WILLIAMSON COUNTY, TEXAS

CHANGE ORDER NUMBER: 5

Project Name: East Wilco Highway Segment 2 Phase 1

**Change Order No. 5**

**TEMPORARY PORTABLE TRAFFIC SIGNALS**

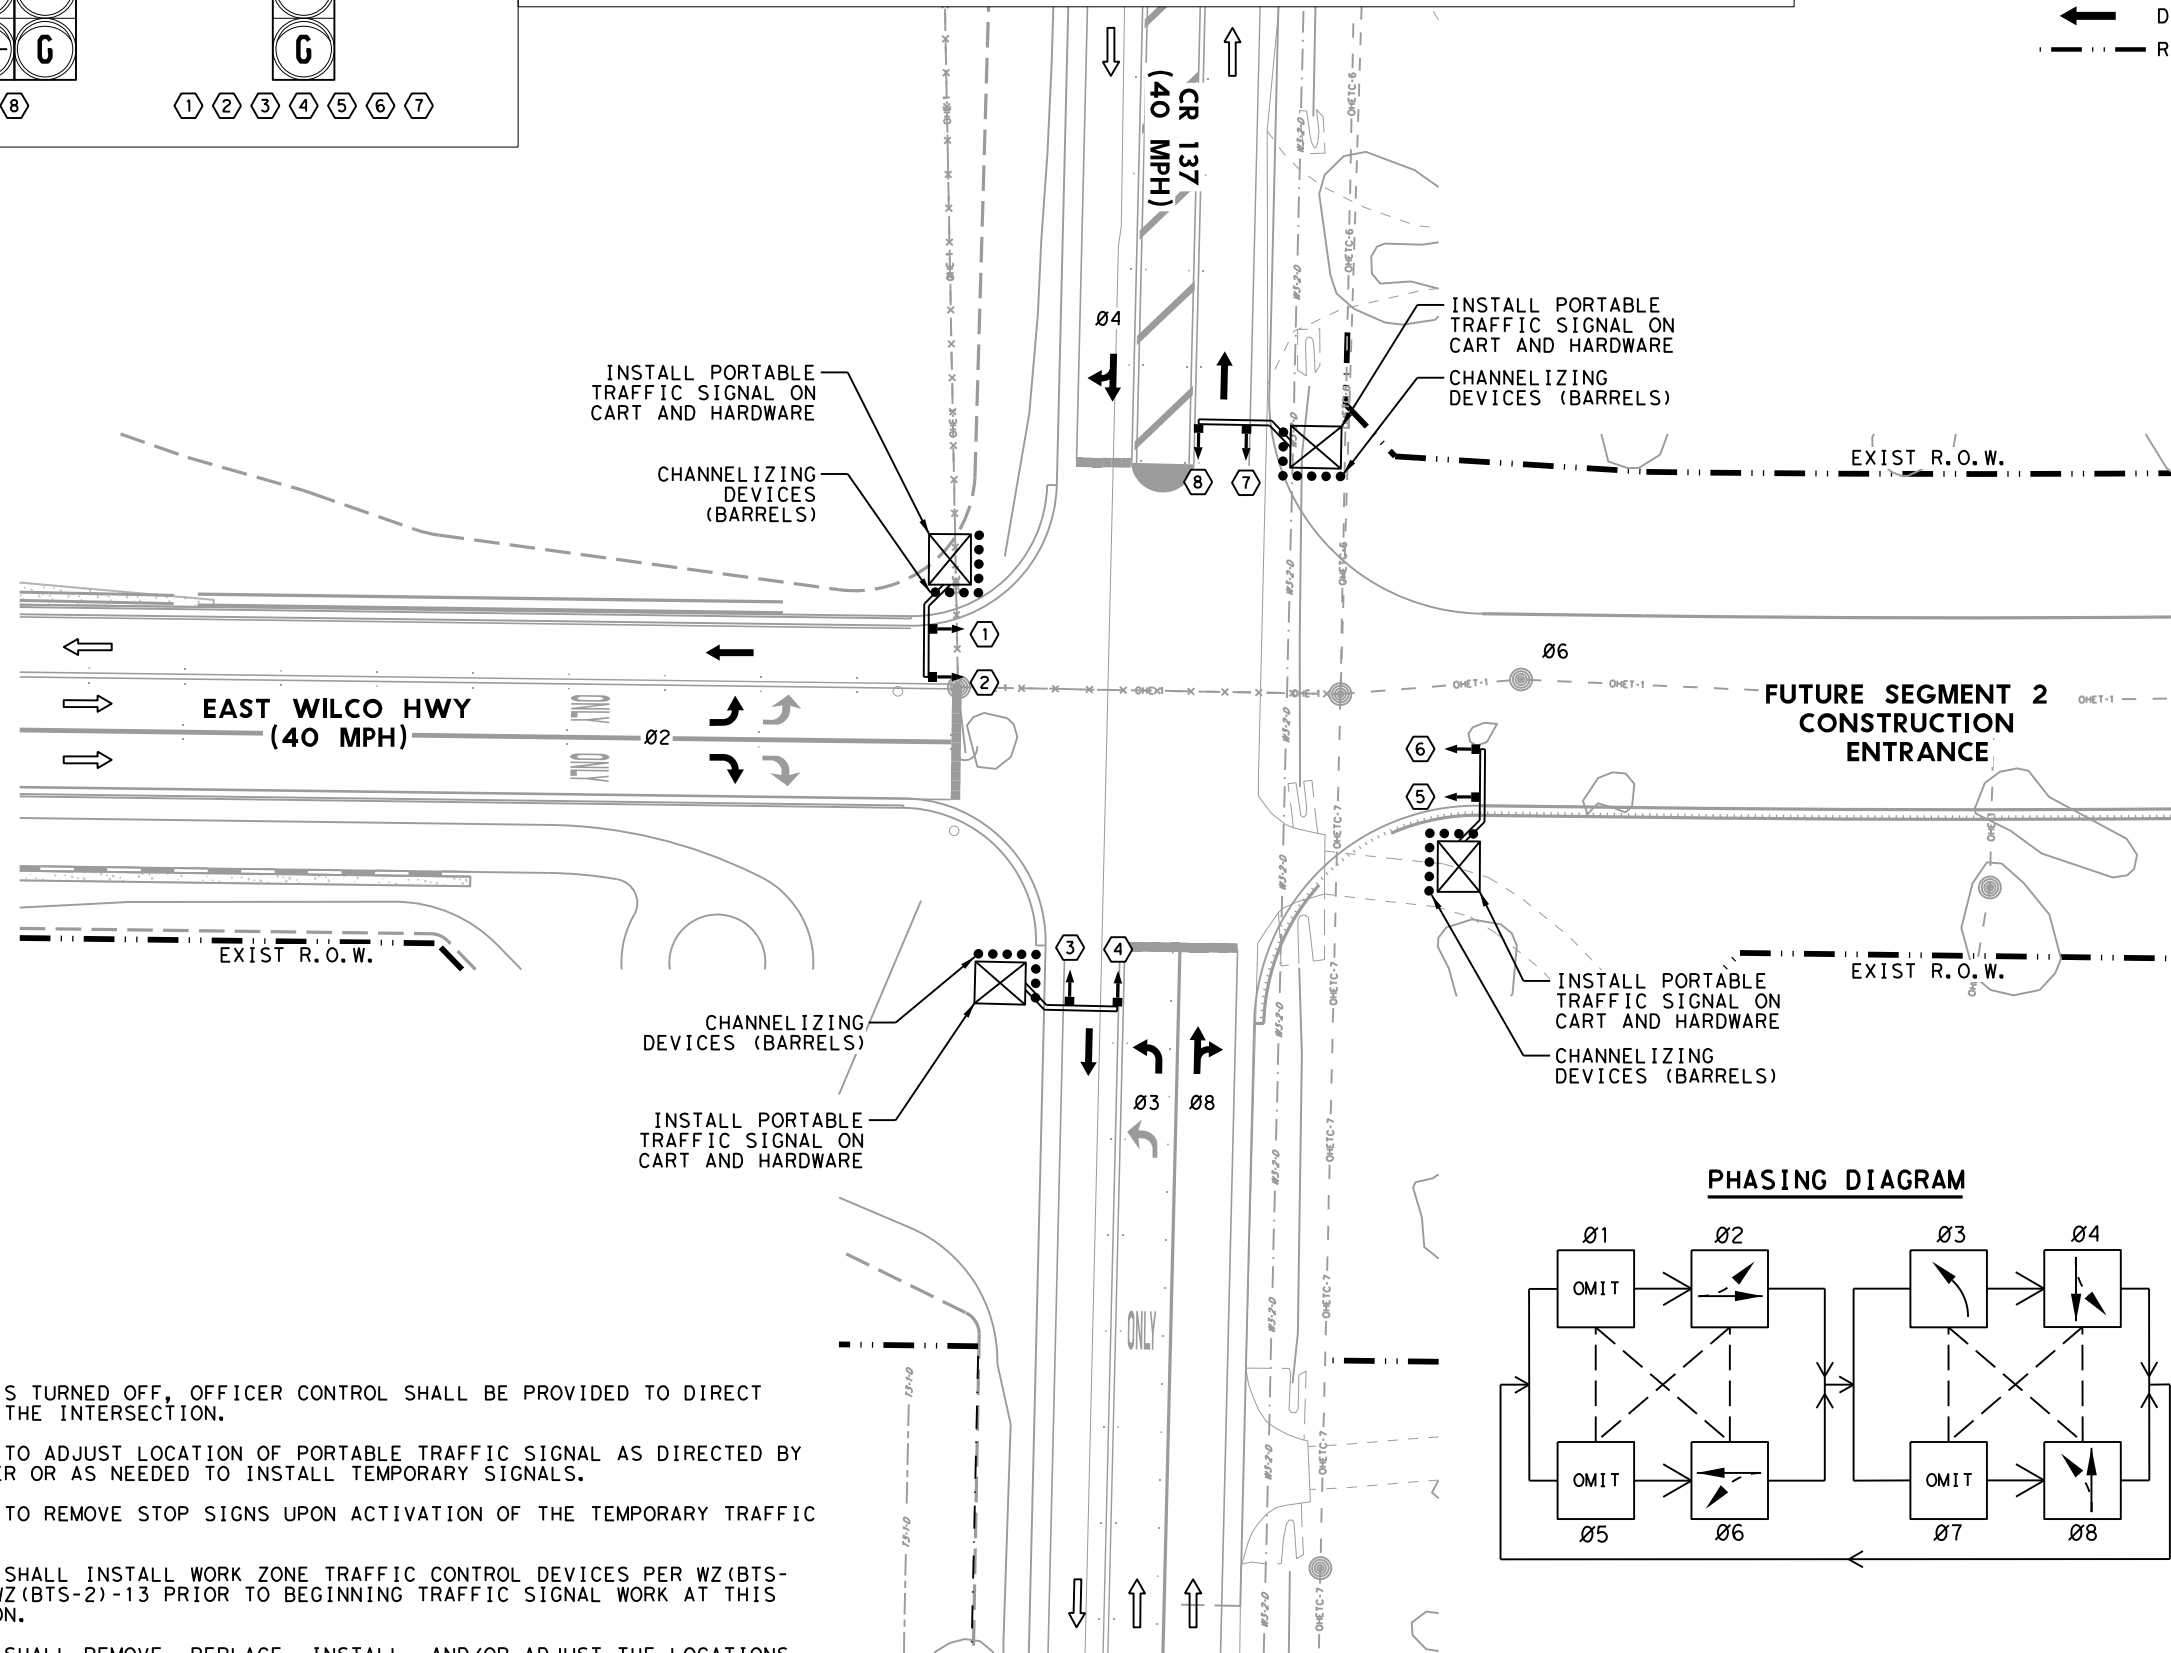
1. TWO PORTABLE CHANGEABLE MESSAGE SIGNS (PCMS) TO BE INSTALLED APPROXIMATELY 1150FT IN ADVANCE FROM NORTHBOUND AND 700FT IN ADVANCE FROM SOUTHBOUND APPROACH STOP-BAR.
2. PORTABLE CHANGEABLE MESSAGE SIGN TO READ "TRAFFIC SIGNAL AHEAD PREPARE TO STOP".
3. PORTABLE CHANGEABLE MESSAGE SIGN TO REMAIN IN USE FROM TIME THAT TRAILER MOUNTED SIGNALS ARE ACTIVATED UNTIL AFTER COMPLETION OF PERMANENT TRAFFIC SIGNAL.

1. IF SIGNAL IS TURNED OFF, OFFICER CONTROL SHALL BE PROVIDED TO DIRECT TRAFFIC AT THE INTERSECTION.
2. CONTRACTOR TO ADJUST LOCATION OF PORTABLE TRAFFIC SIGNAL AS DIRECTED BY THE ENGINEER OR AS NEEDED TO INSTALL TEMPORARY SIGNALS.
3. CONTRACTOR TO REMOVE STOP SIGNS UPON ACTIVATION OF THE TEMPORARY TRAFFIC SIGNAL.
4. CONTRACTOR SHALL INSTALL WORK ZONE TRAFFIC CONTROL DEVICES PER WZ(BTS-1)-13 AND WZ(BTS-2)-13 PRIOR TO BEGINNING TRAFFIC SIGNAL WORK AT THIS INTERSECTION.
5. CONTRACTOR SHALL REMOVE, REPLACE, INSTALL, AND/OR ADJUST THE LOCATIONS OF STOP BAR PAVEMENT MARKINGS AS DIRECTED BY THE ENGINEER.

**PROPOSED SIGNING & PAVEMENT MARKINGS LAYOUT**

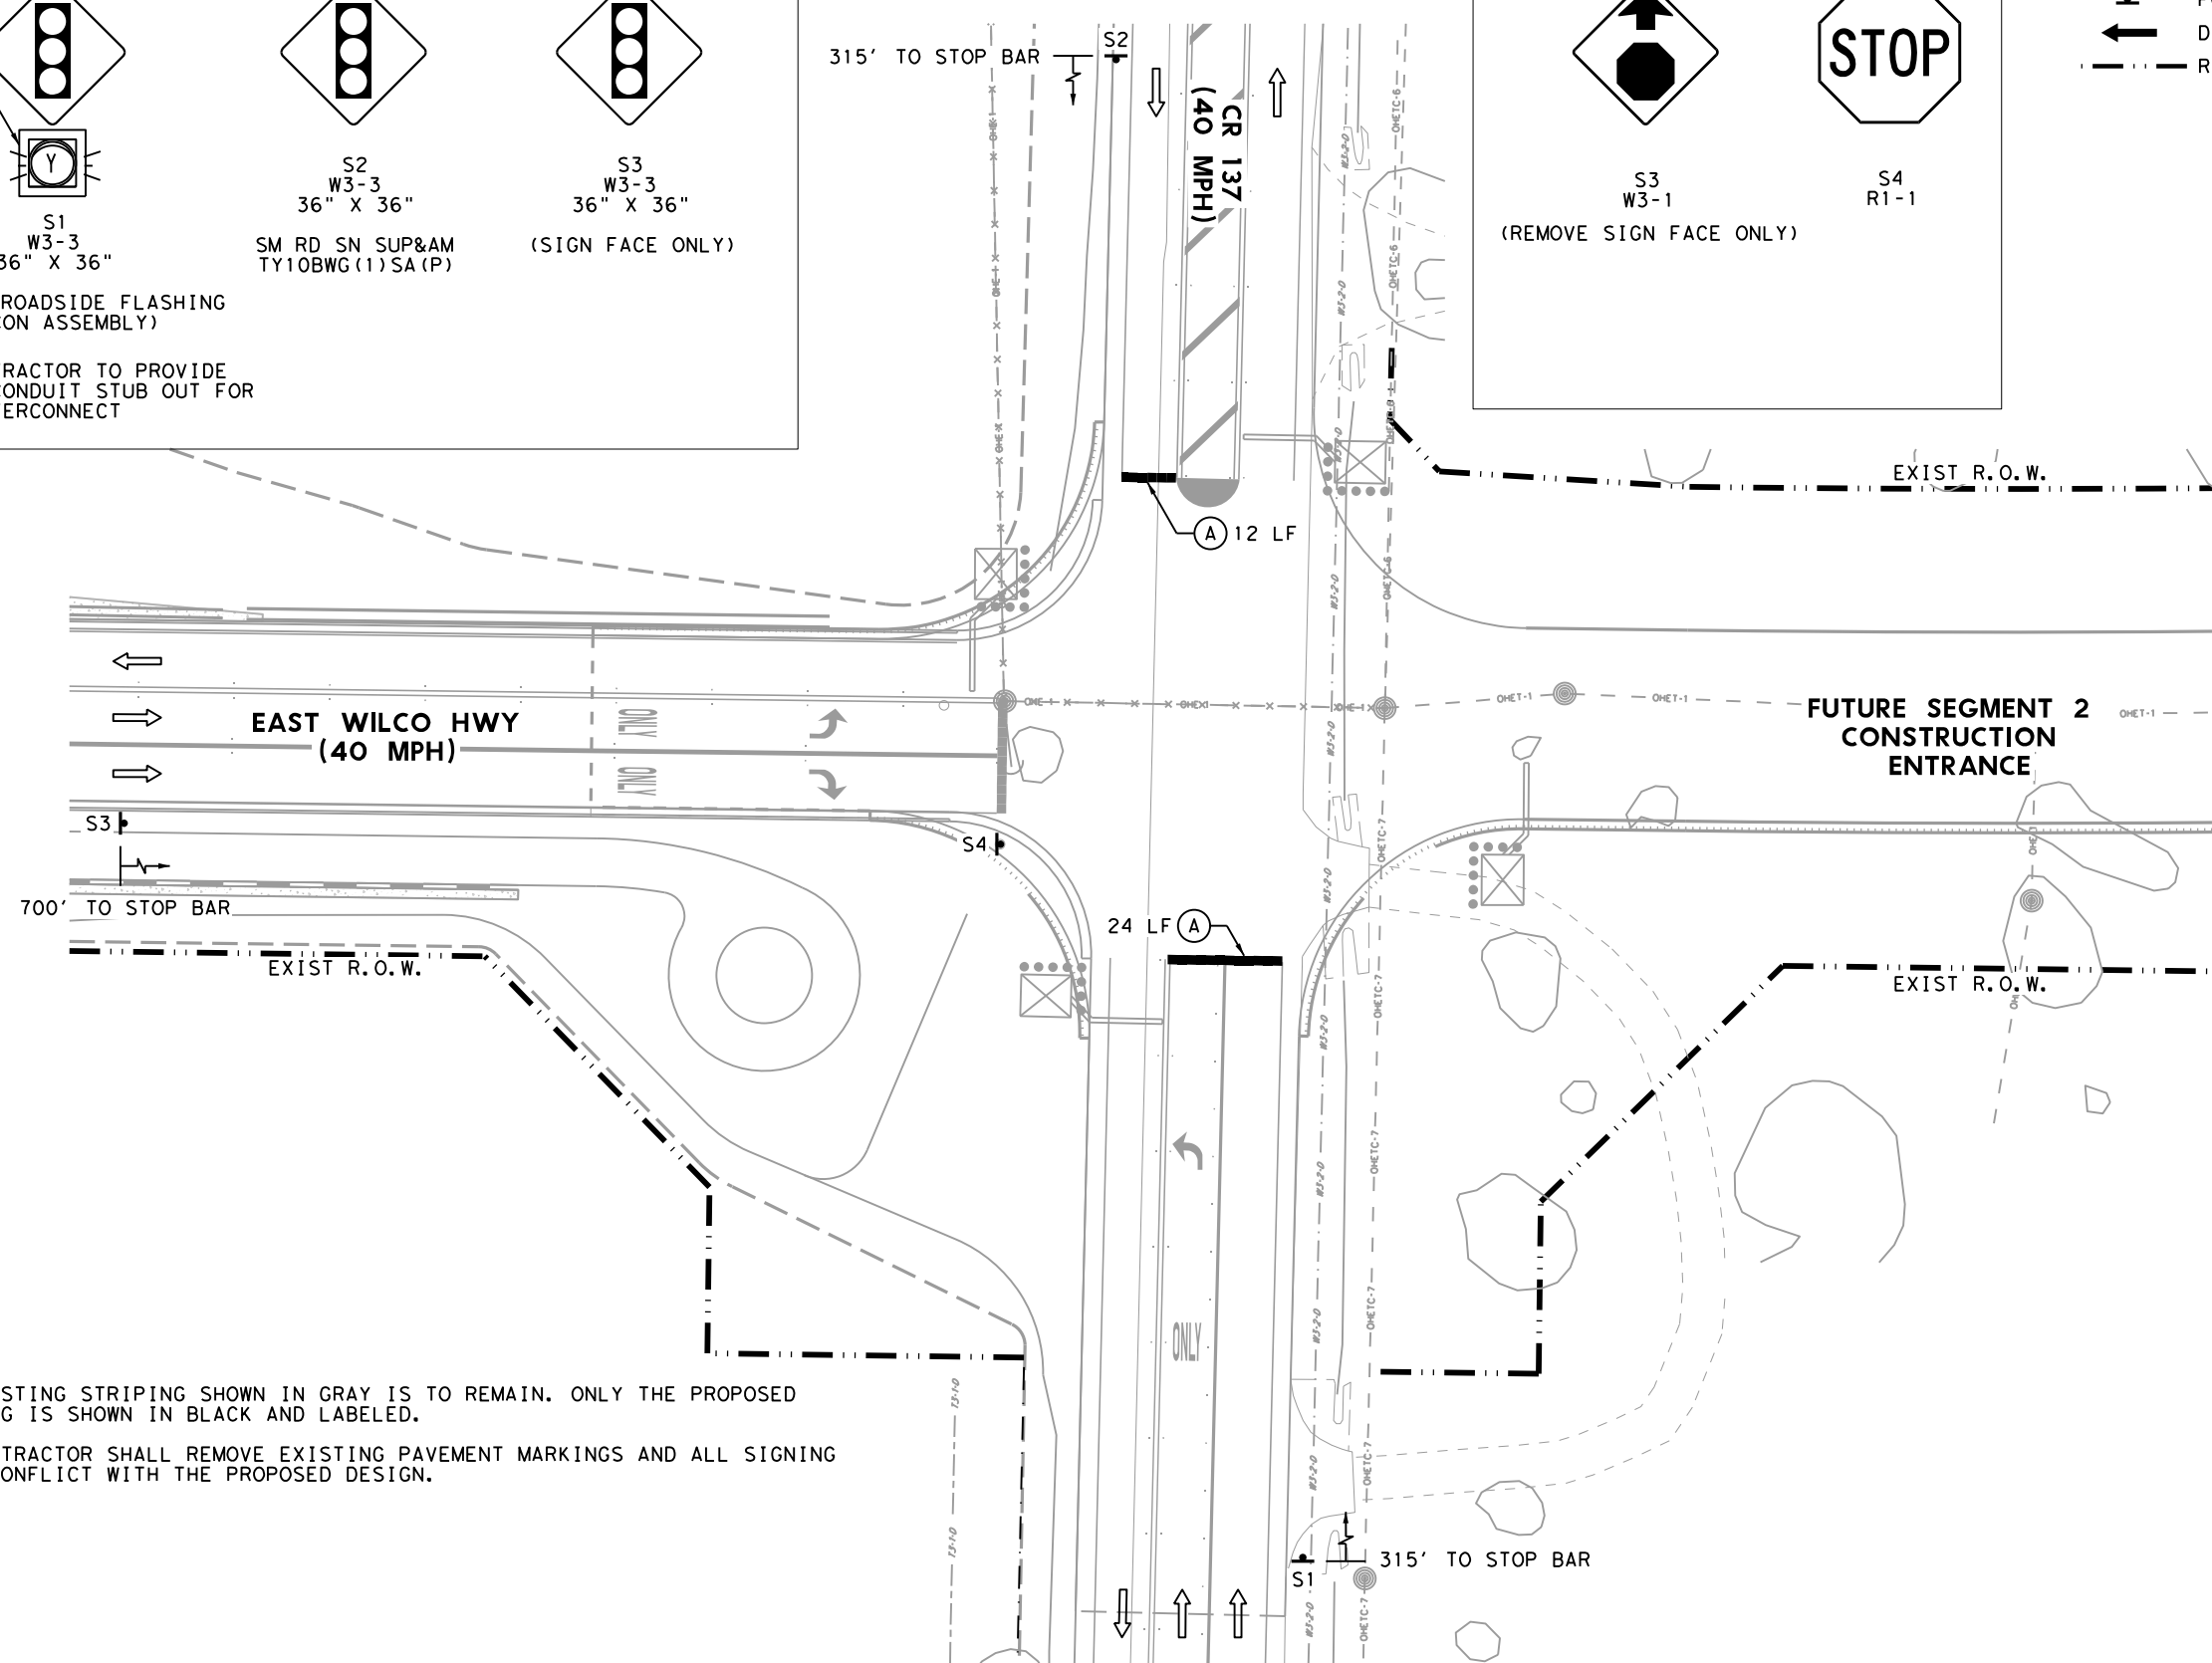
- ### NOTES:
1. THE EXISTING STRIPING SHOWN IN GRAY IS TO REMAIN. ONLY THE PROPOSED STRIPING IS SHOWN IN BLACK AND LABELED.
  2. THE CONTRACTOR SHALL REMOVE EXISTING PAVEMENT MARKINGS AND ALL SIGNING WHICH CONFLICT WITH THE PROPOSED DESIGN.
